DESCRIPTION Expansion Dam Detail
PROJECT Sandy River Bridge Proj. No. BH-025-2(46)
LOCATION New Sharon, Me.
DESIGNER Me. D.O.T.
CUSTOMER Callahan Bros., Inc.
JOB NO. 89-670-4
DWG. NO. 22
REV. ②

STATE OF MAINE
DEPARTMENT OF TRANSPORTATION
☒ Approved ☐ Returned for Corrections
AUG 16 1989
☐ Approved as noted ☐ Rejected
K. Jacobs
WELDING ENGR.

DESCRIPTION SPLICE PLTS FOR LINK RETROFIT
PROJECT SANDY RIVER BRIDGE PROJ. No. BH-025-4(26)
LOCATION NEW SHARON, ME
DESIGNER ME DOT
CUSTOMER CALLAHAN BROS.
JOB NO. 89-670-2   DWG. NO. 1   REV. (A)

DETAIL OF pc21

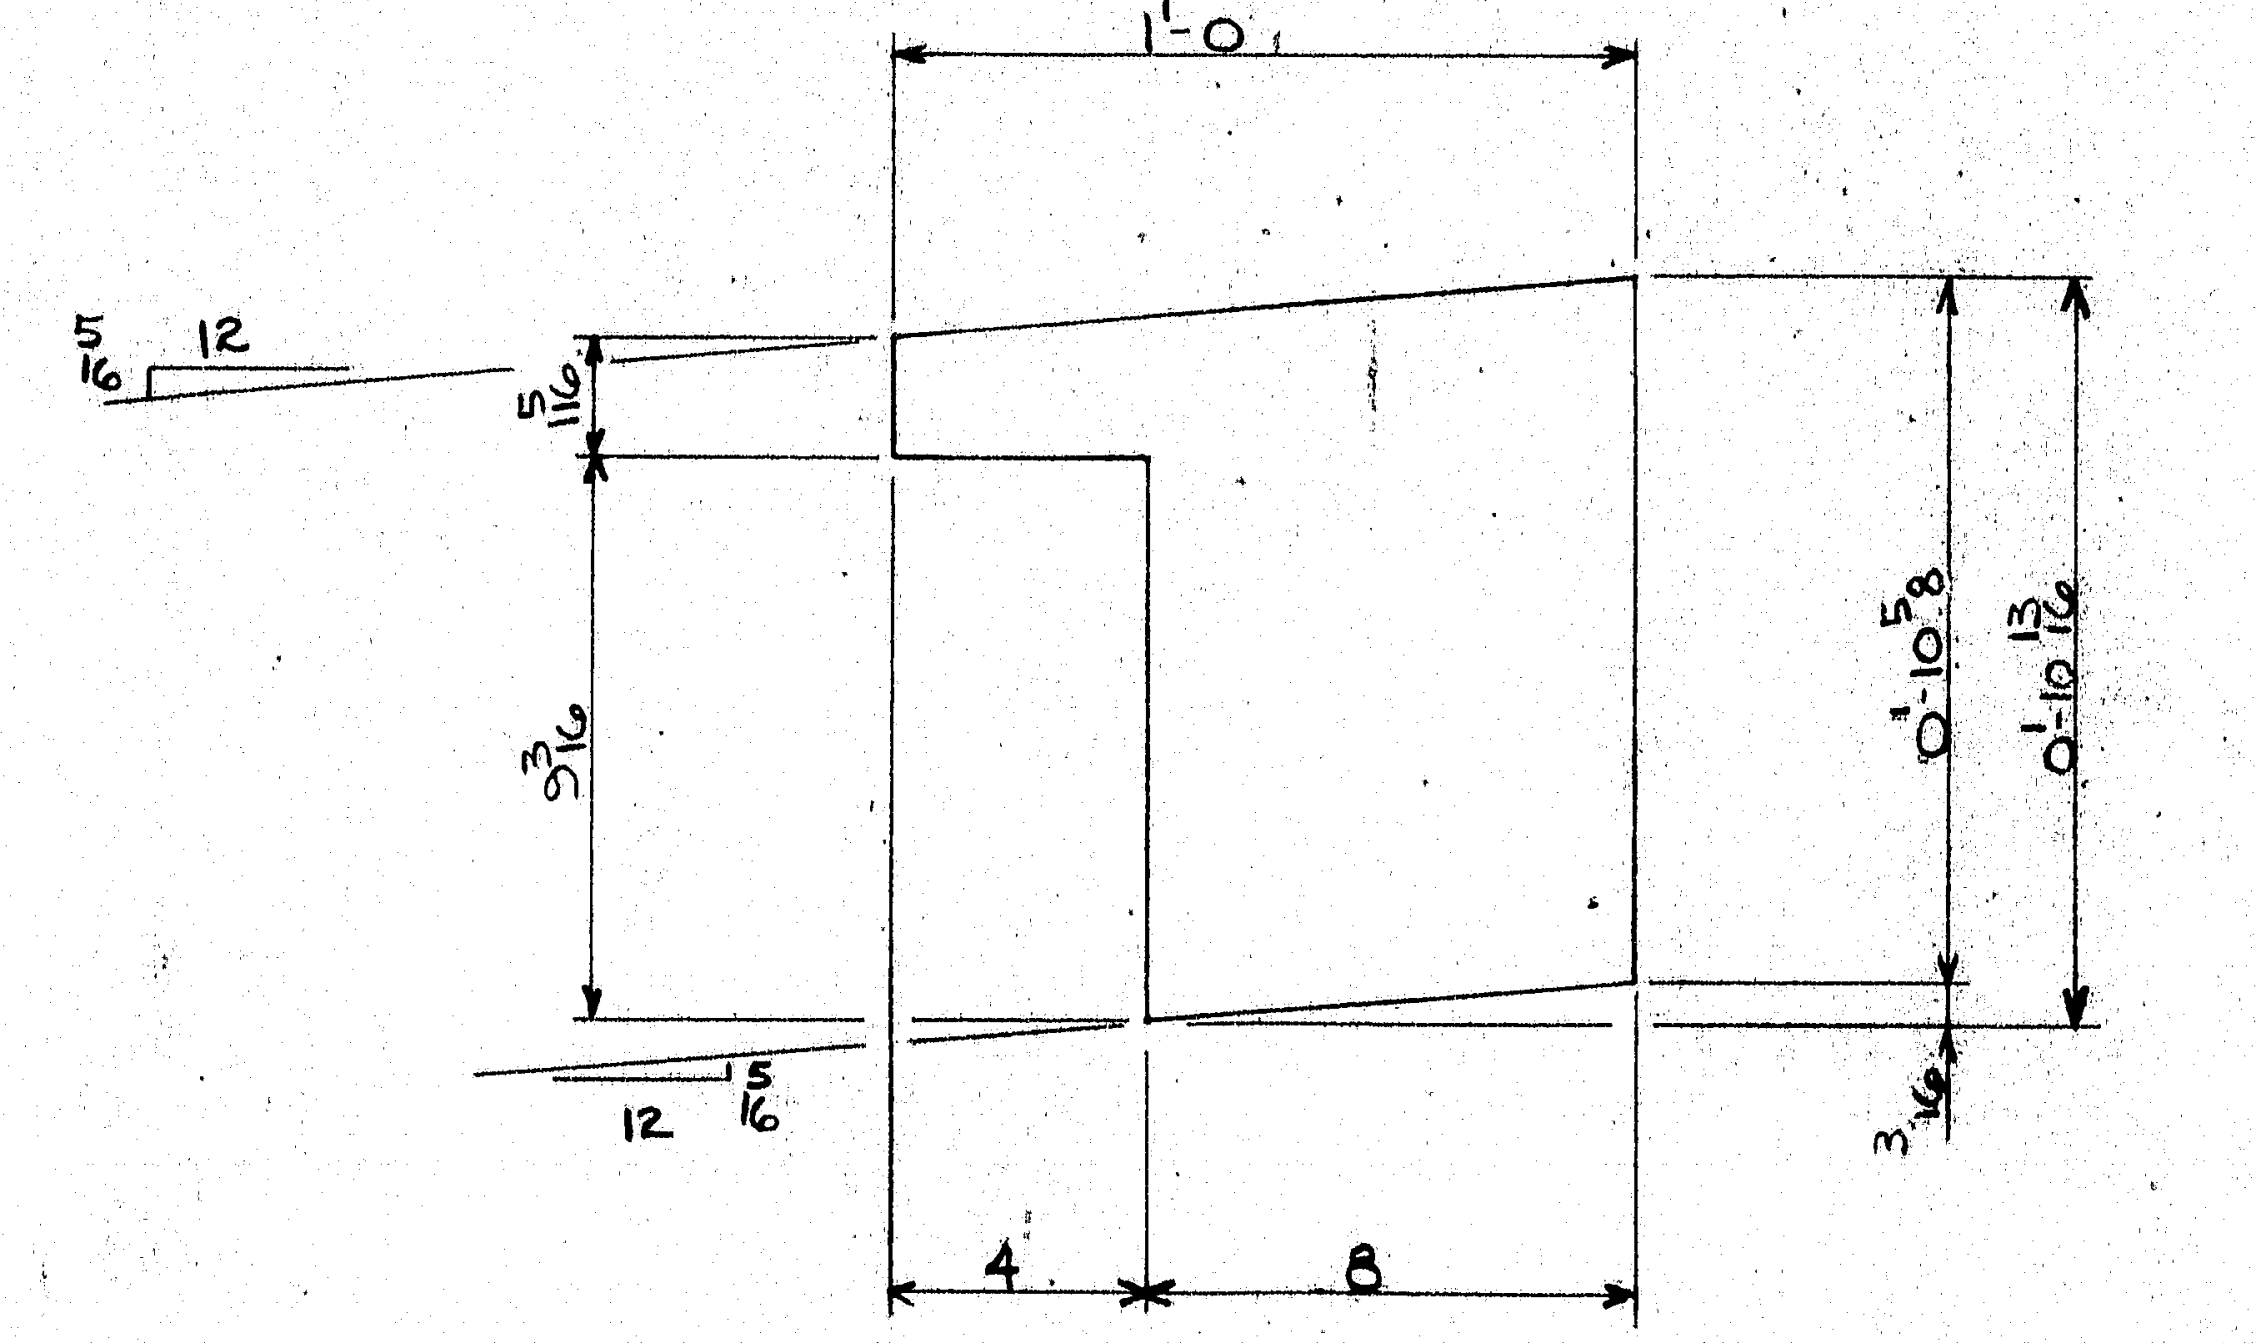
⚠A REVISED PER APPROVAL ⚠1 CHANGED 1'-6 TO 1'-6 1/2 & ADDED DIMENSIONS.

DESCRIPTION Expansion Pedestal @ Pier #4
PROJECT Sandy River Bridge BH-025-2 (46)
LOCATION New Sharon, Me.
DESIGNER Me. D.O.T
CUSTOMER Callahan Bros., Inc
JOB NO 89-670-1
DWG. NO 5
REV. 4

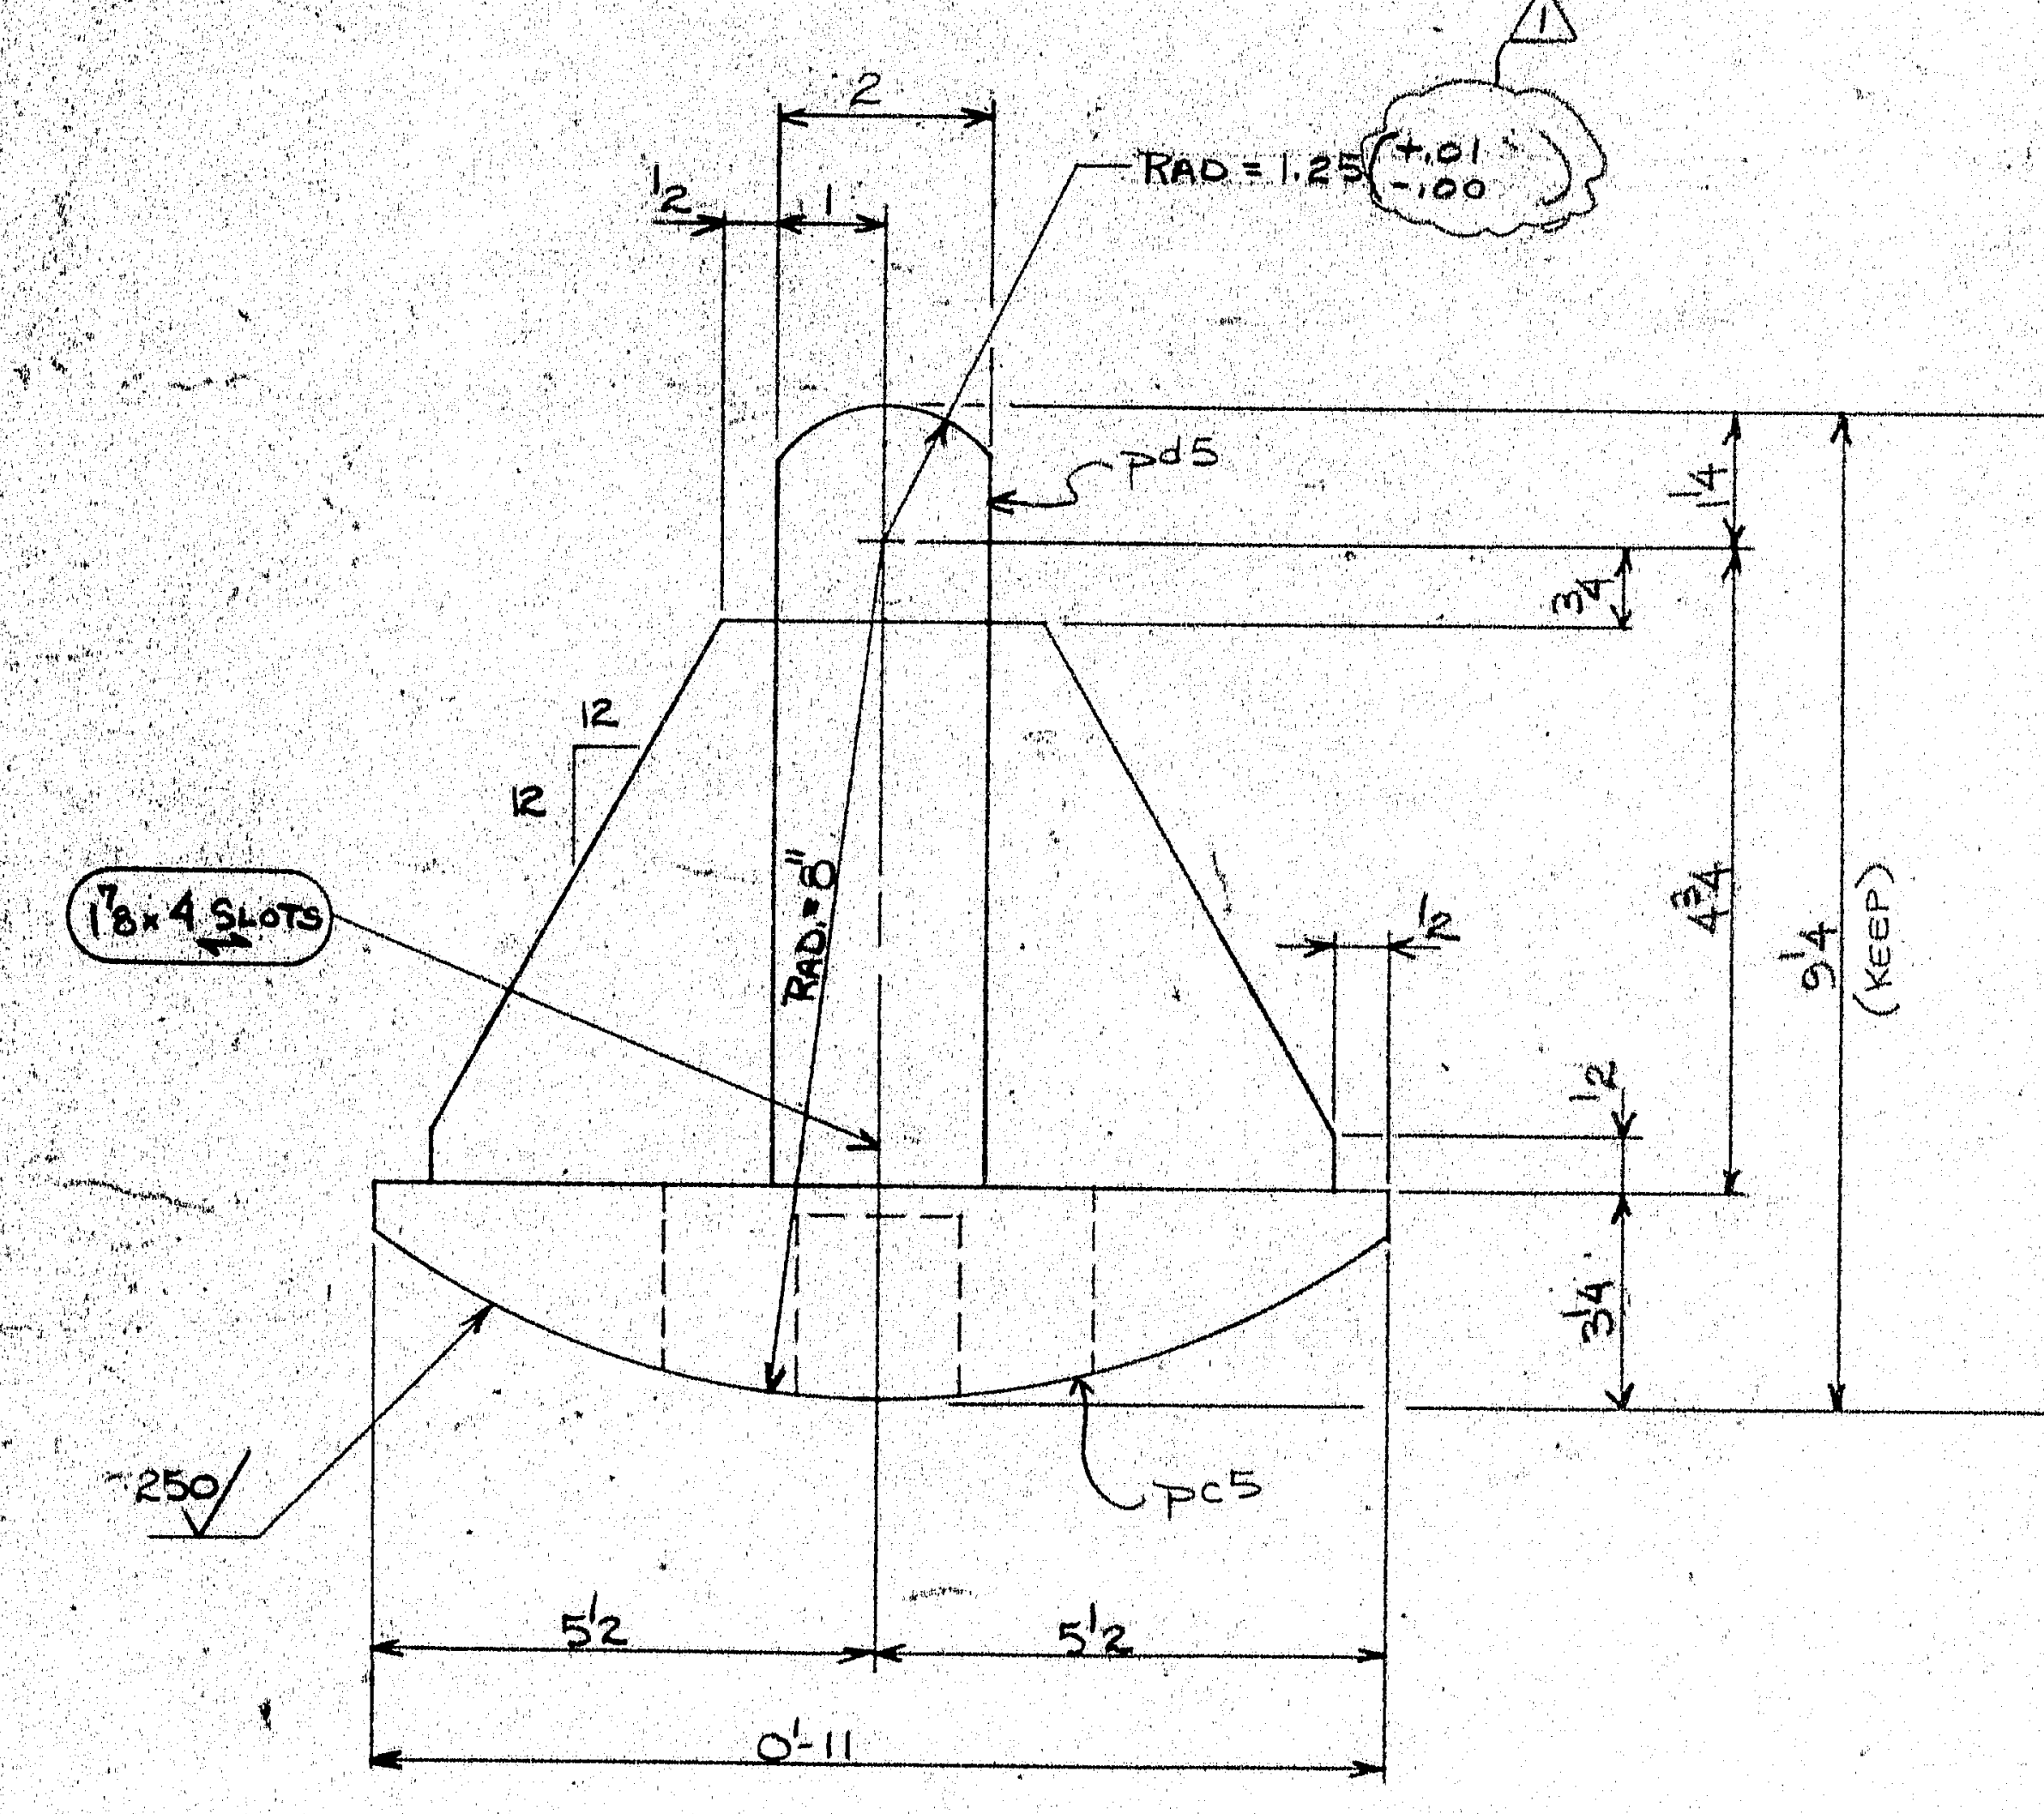
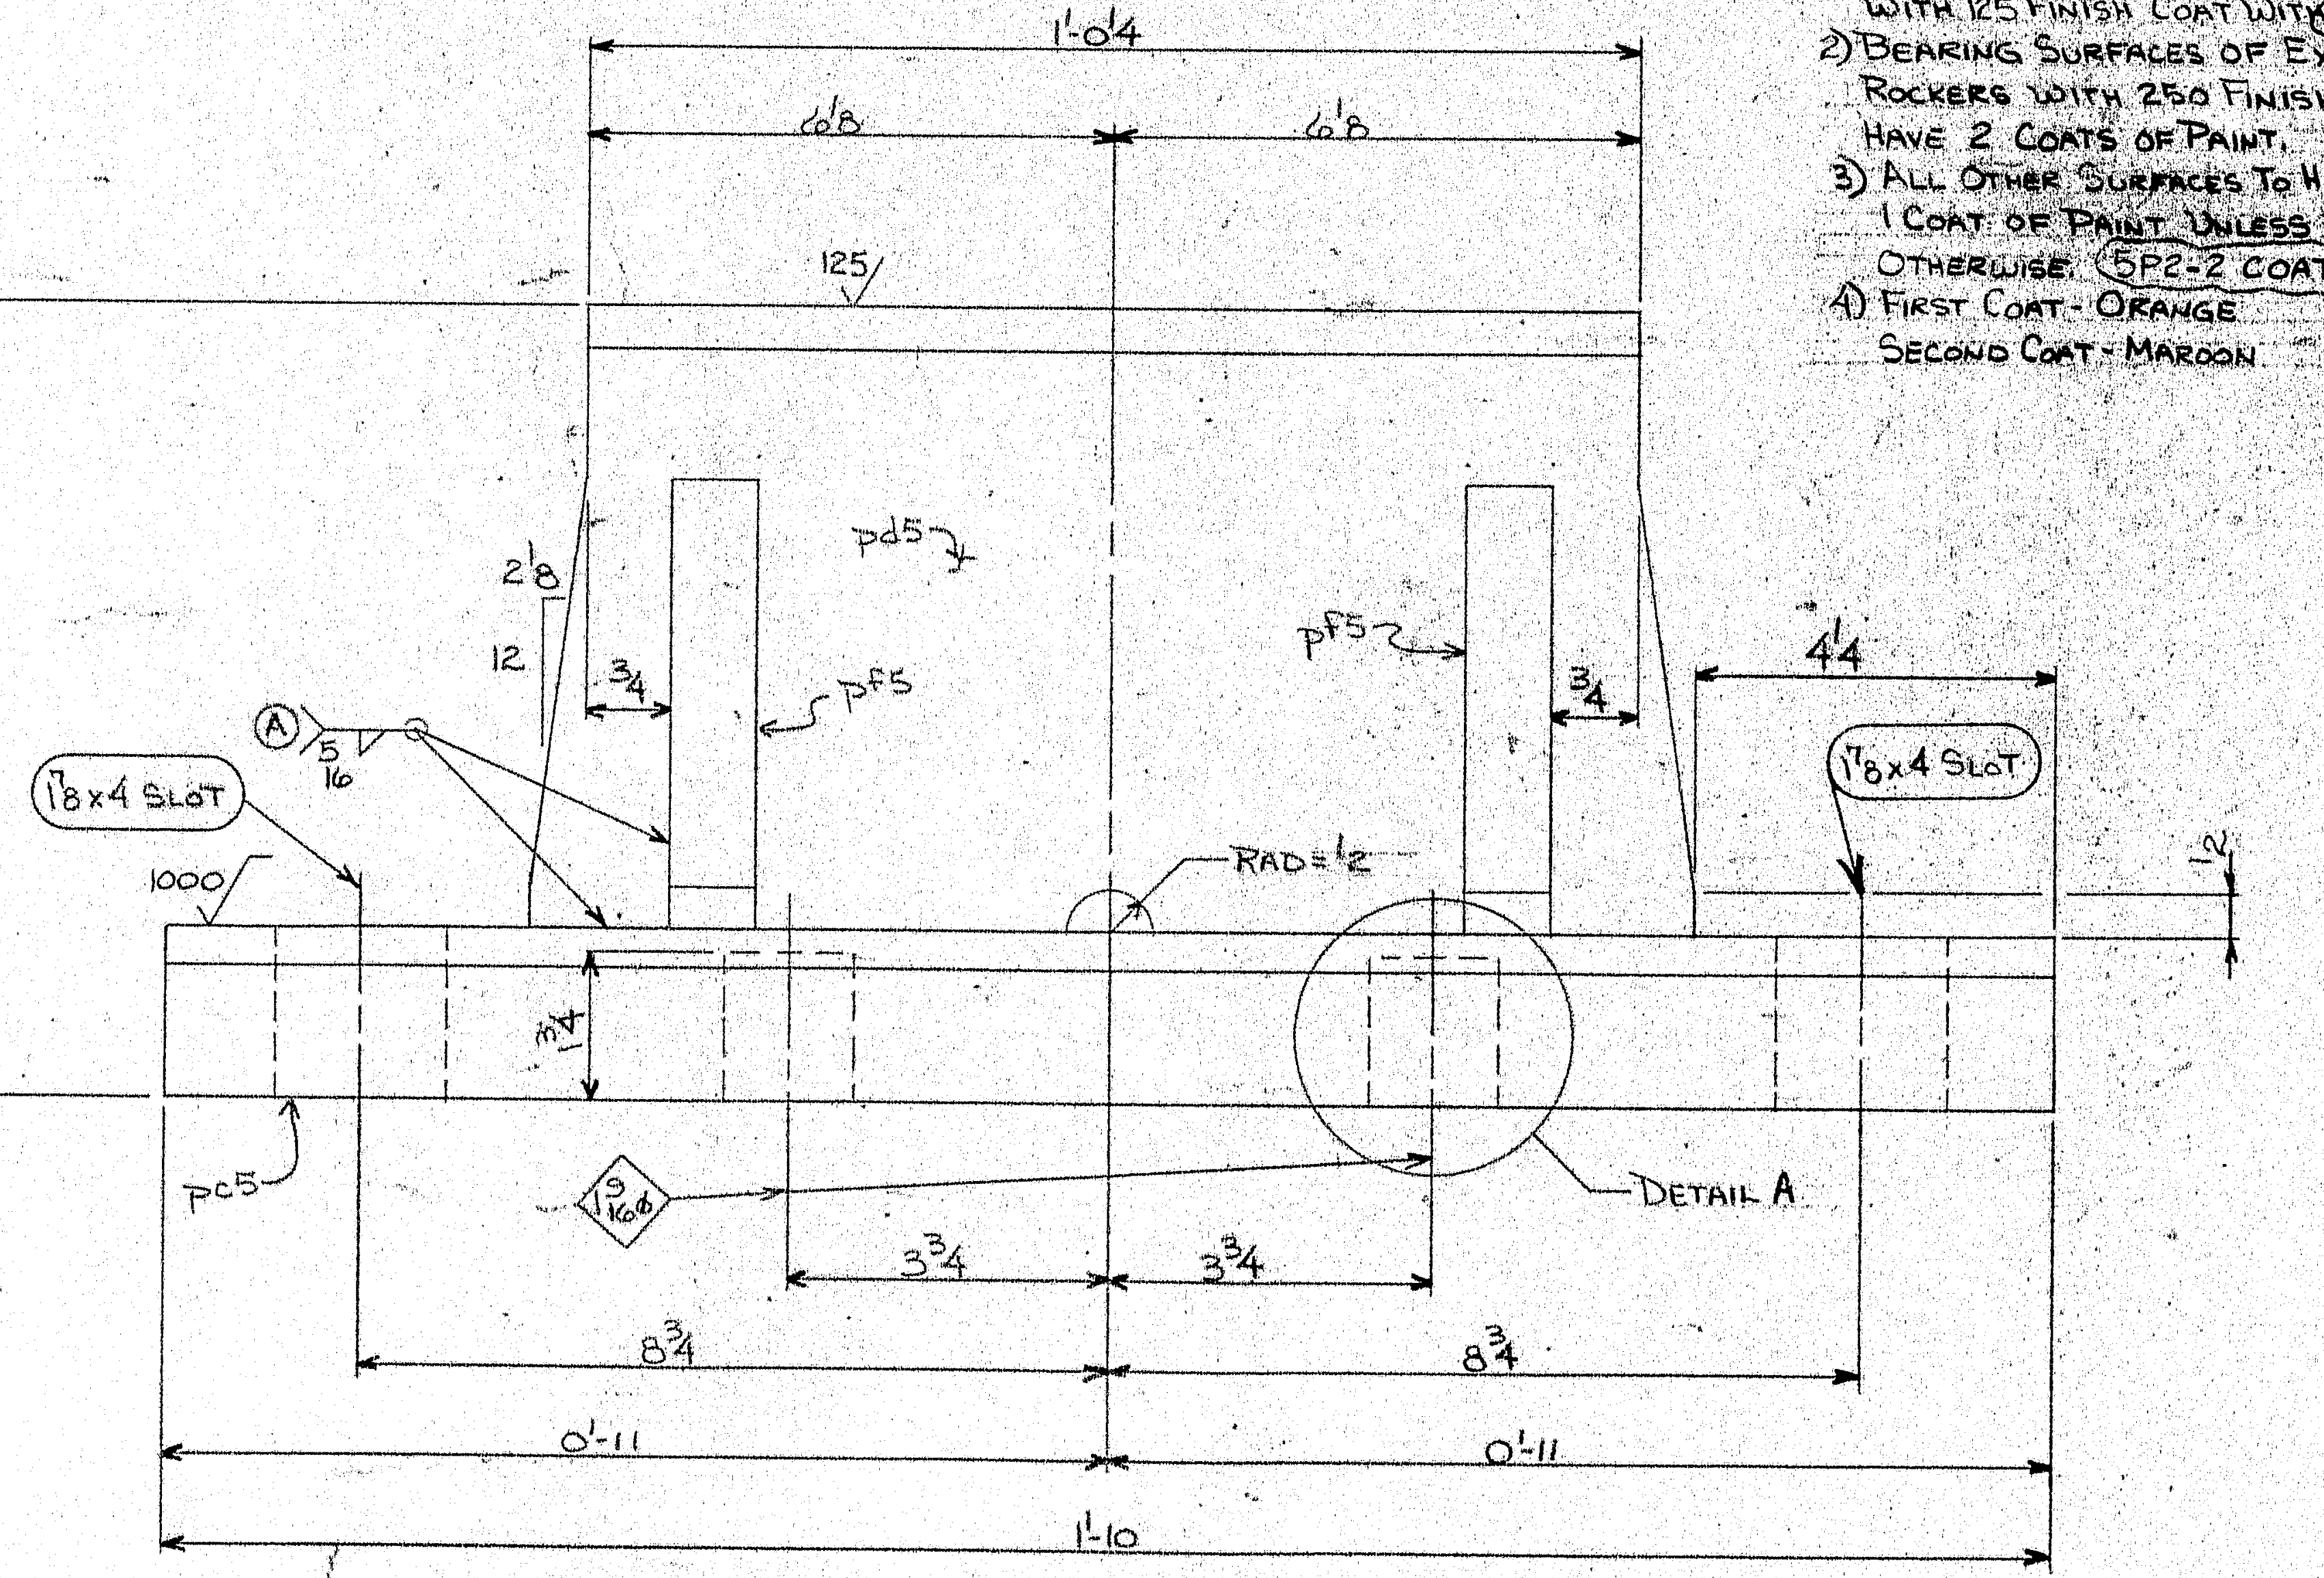
Paint Notes: specifications plus !!!
